UNITED STATES PATENT AND TRADEMARK OFFICE

APPLICATION NO.	FILING DATE	FIRST NAMED INVENTOR	ATTORNEY DOCKET NO.	CONFIRMATION NO.
09/613,903	07/11/2000	Heather J. Jordan	0942.4450001	1446
26111	7590	11/26/2004	EXAMINER	
STERNE, KESSLER, GOLDSTEIN & FOX PLLC 1100 NEW YORK AVENUE, N.W. WASHINGTON, DC 20005			SISSON, BRADLEY L.	
			ART UNIT	PAPER NUMBER
			1634

Office Action Summary

DETAILED ACTION

FIG.2

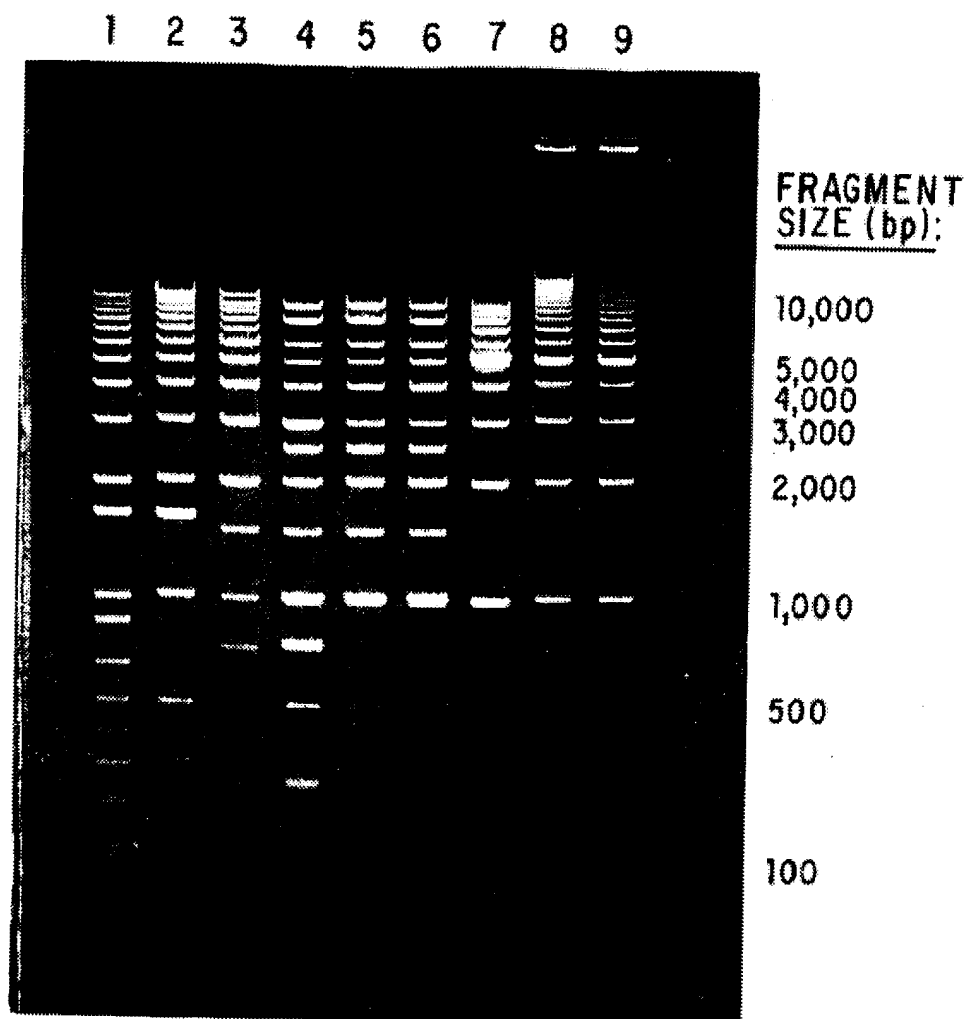
Figure 2, Lane 1, is construed to contain bands that range in size from about 200 bp to about 10,000 bp, however, the bands from about 500 bp 200 bp in length are considered to be at significantly less intensity than the intensity of bands viewed higher in the gel. Accordingly, the bands from 500 to 200 are not considered to fall within the presently claimed invention, which stipulates that the bands are of "substantially equal intensity." Furthermore, neither the lane, nor any other part of the disclosure has been found to provide an adequate written description of other embodiments of the claimed invention in such full clear and concise language so as to

28. To the extent that Figure 2, lane 1 exemplifies the claimed invention, it is noted that there is significant variance in the intensity of the bands present.

The degree of variance between the bands as found in Lane 1 of Figure 2 is considered to be no less than the degree of variance between bands found in the prior art.
